UNITED STATES PATENT AND TRADEMARK OFFICE

APPLICATION NO.	FILING DATE	FIRST NAMED INVENTOR	ATTORNEY DOCKET NO.	CONFIRMATION NO.
10/796,938	03/09/2004	Ron Naftali	6317P024	4473

Office Action Summary	Application No. 10/796,938	Applicant(s) NAFTALI, RON	
	Examiner Michael Liu	Art Unit 2882

DETAILED ACTION

Drawing 1 Fig 3 with first cross-section labeled.

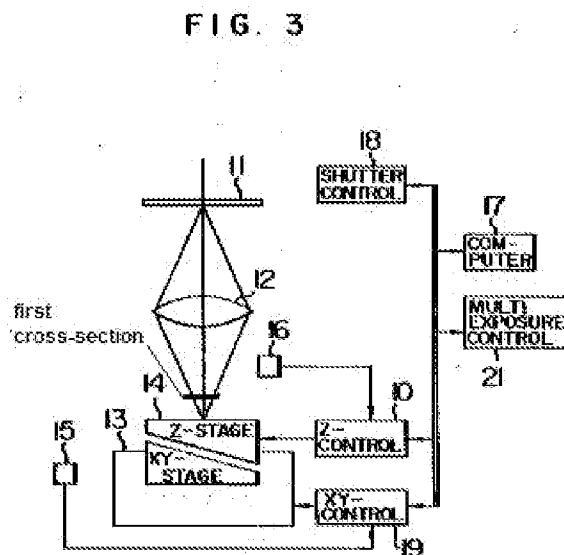
Claims 5 and 1: Fukuda discloses a system [Fig 3] for recording a pattern 11, comprising:

a controller 17, for determining an illumination scheme [via exposure control system 21] in response to the pattern; and

optics [C9L49-50: shutter controlled by shutter control system 18], coupled to the controller, for directing, in response to the determination, at least one beam of radiation [C11L62-63: excimer laser] having a first cross-section [Drawing 1] towards a reversible transmission film 44 [Fig 8c] that allows a portion of said beam to propagate towards a radiation sensitive layer 42, wherein the portion has a second cross-section [Fig 8d: grooves between 46] that is smaller than the first cross-section.

Claims 7 and 3: Fukuda discloses wherein the second cross-section [Fig 8d] is about half of the first cross-section [Drawing 1].
